APPEAL SUMMARY

Status: Decision Rendered - Reconsideration of ID 16413

Appeal ID: 16560	Project Address: 1314 NW Glisan St
Hearing Date: 2/28/18	Appellant Name: Anne Marie Kuban
Case No.: B-002	Appellant Phone: 5032359400
Appeal Type: Building	Plans Examiner/Inspector: David Bartley
Project Type: commercial	Stories: 2 Occupancy: A-2, B Construction Type: V-B
Building/Business Name: Andina Restaurant	Fire Sprinklers: Yes - Throughout
Appeal Involves: Reconsideration of appeal, occ Change from A2, B, M to A2, B	LUR or Permit Application No.: 17-266543-CO
Plan Submitted Option: pdf [File 1]	Proposed use: Restaurant

ANDINA RESTAURANT
SEISMIC UPGRADE AND CHANGE OF USE
1314 NW GLISAN
PORTLAND, OR 97209

REV. #:	DATE:	DESCRIPTION:
1	10/20/17	ADDENDUM 1
2	1/12/18	PERMIT REVISIONS
3	1/19/18	PERMIT REVISIONS
4	1/25/18	PERMIT REVISIONS
5	2/12/18	PERMIT REVISIONS

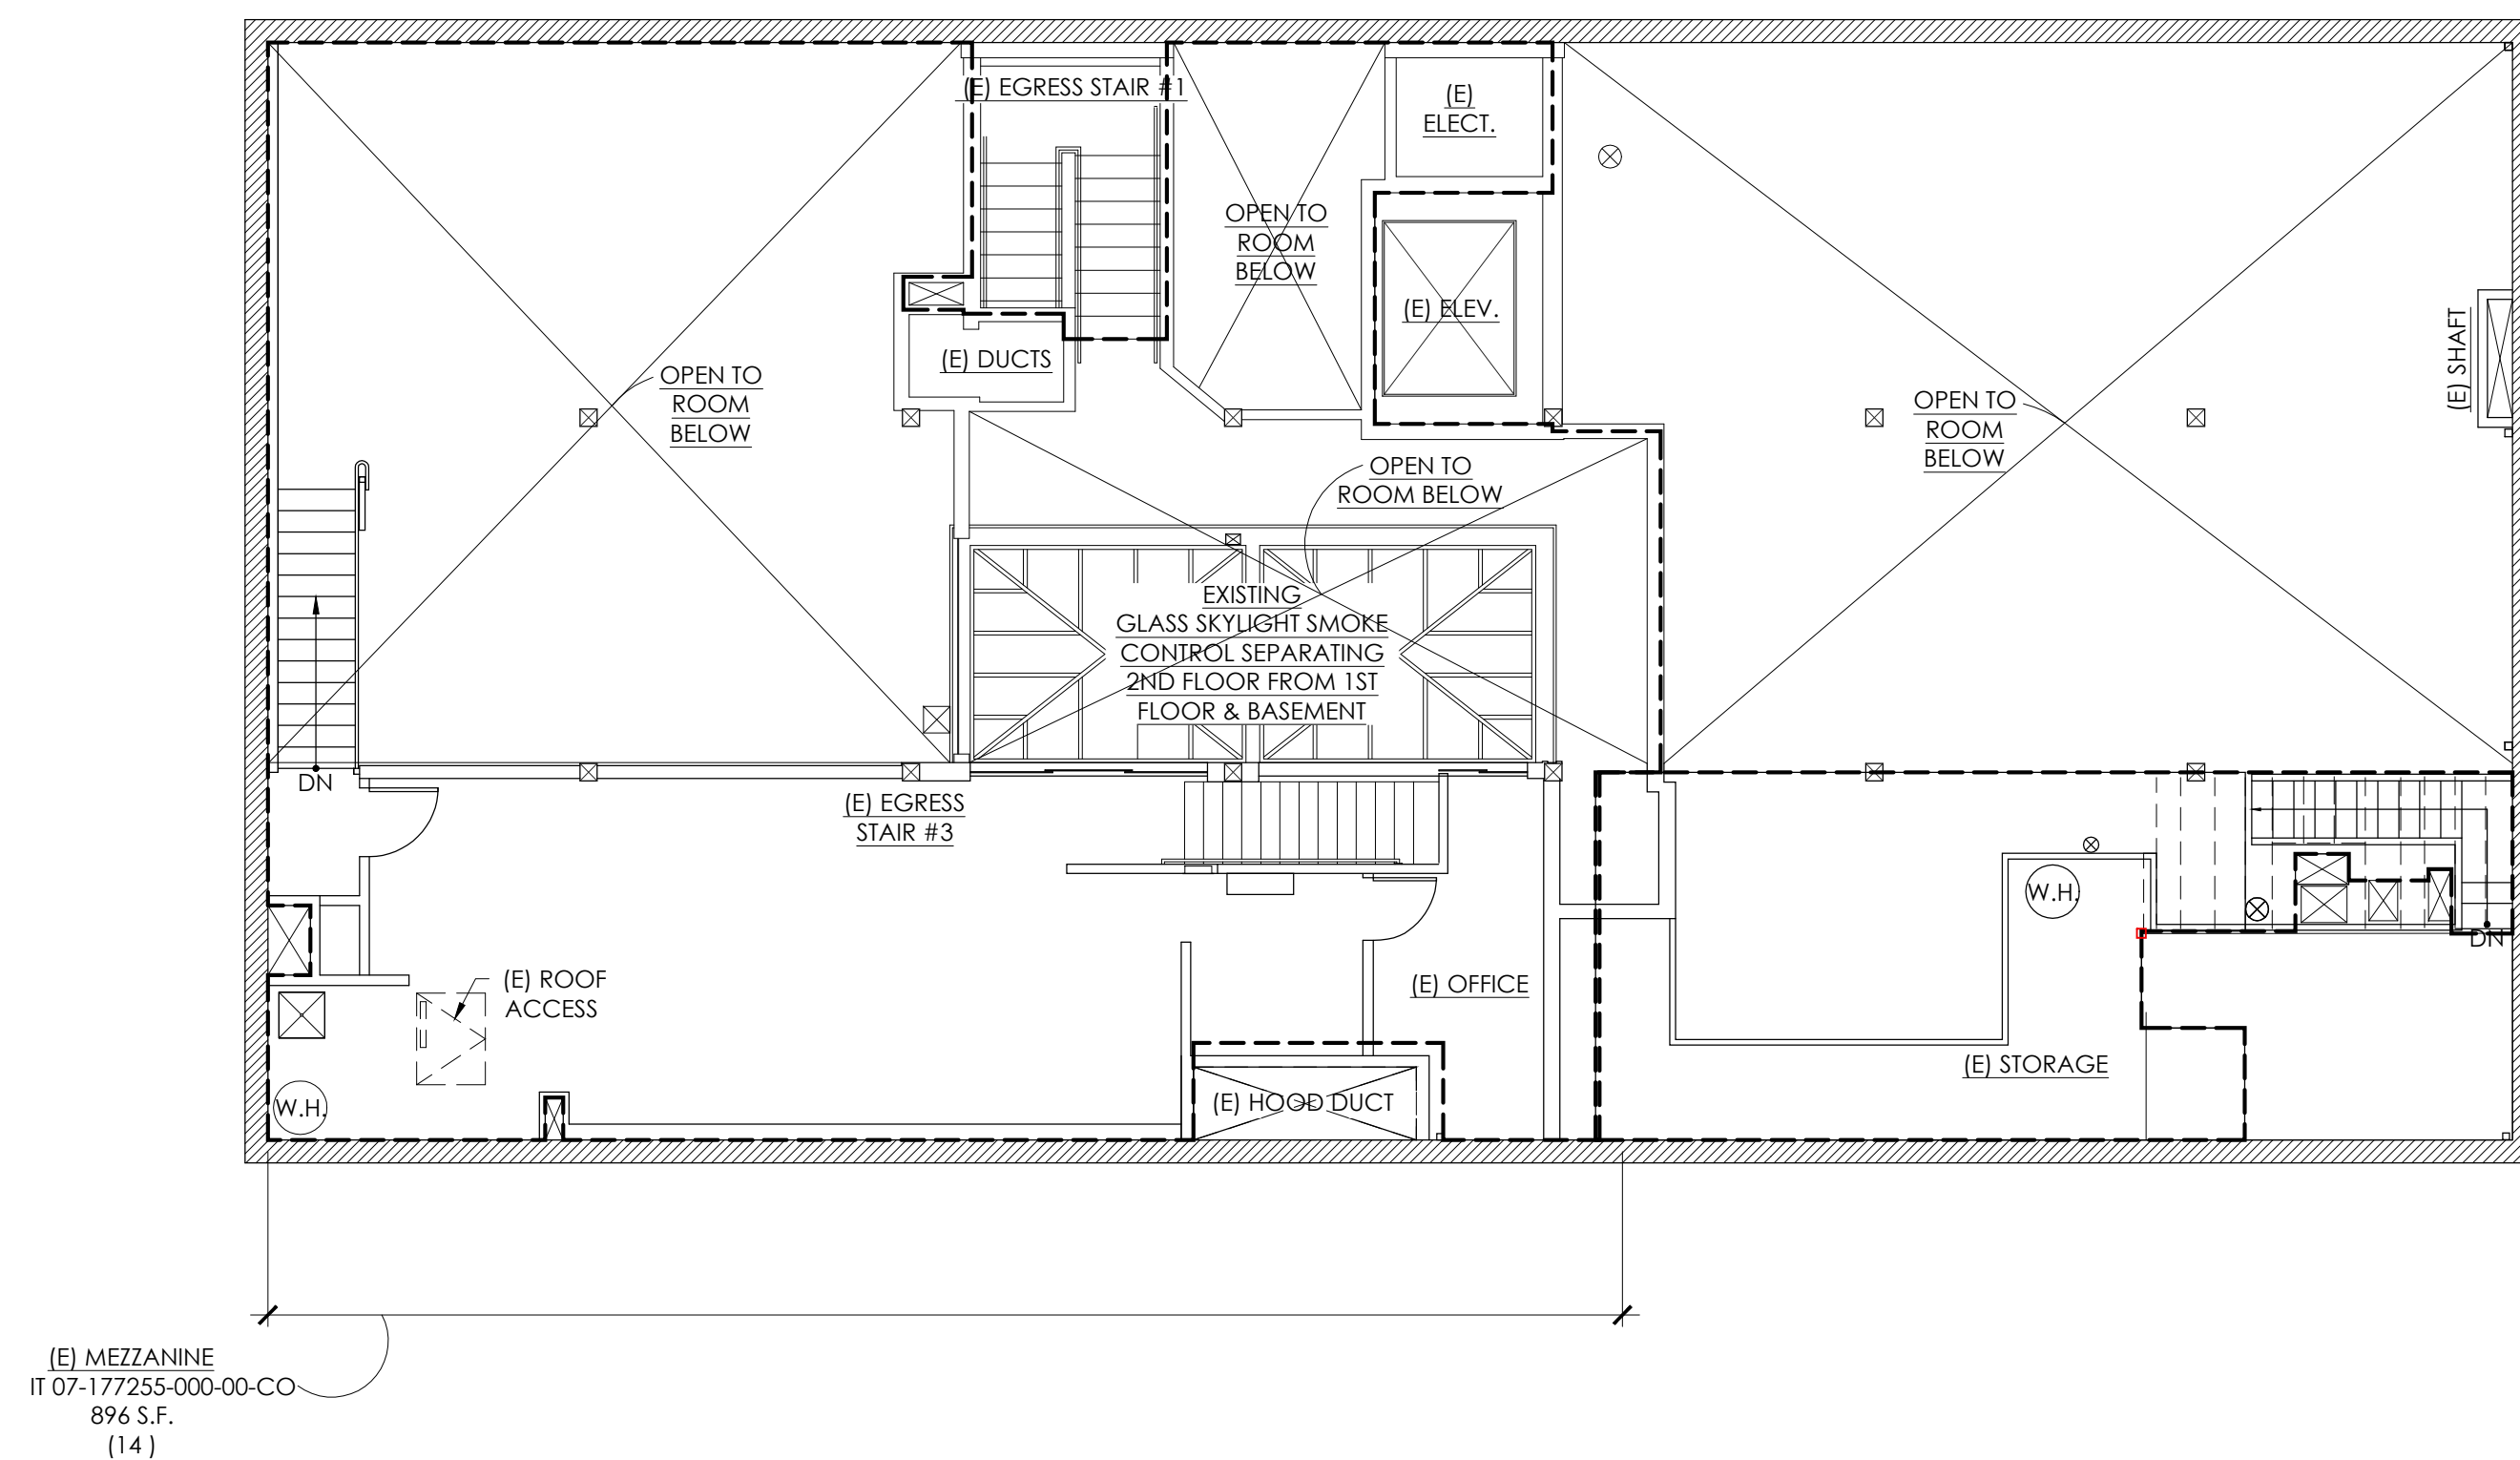
The planchecker indicated that the revised mezzanine design... "The proposed changes do not resolve the fact that the 2nd floor of the building is not one connected room. A mezzanine exists within a room, and is limited to being 1/3 of the area of that room. The existing mezzanine was appealed in 2005 to be slightly more than 1/3 of the room it was in (the banquet room). That situation has not changed. The 2nd floor is still separated into separate rooms". As a result of this interpretation, the planchecker is indicating that we need to place a wall and a door to separate the 2 mezzanines because they open into 2 different spaces. Please see mark-up on G0.5

Whether or not we can "reuse" Appeal 1543 provisions, the current design meets the letter of the code by having the current mezzanine design equal to 1/3 the area of the room(s) below.

Information on G0.5 is annotated in BLUE.

In response to the second item of concern, OSSC 505.2.1 does not prohibit multiple rooms or spaces on a floor having mezzanines. Also this Section states that ...the aggregate area of a mezzanine or mezzanines... indicating a projects could have more than one mezzanine.

The proposed wall and door separating the mezzanine has no value as a fire or smoke separating device; it would not have to be rated or follow smoke provisions in the code. It is dividing a space of the same two occupancies.

Information on G0.5 is annotated in GREEN.

- 1. Mezzanine area greater than one third of the room it is open to: Denied. Proposal does not provide equivalent Life Safety protection.**
Appellant may contact Jody Orrison (503 823-4539) with questions.
- 2. Mezzanine openness to the room it is within: Denied. Proposal does not provide equivalent Life Safety protection.**
Appellant may contact Jody Orrison (503 823-4539) with questions.
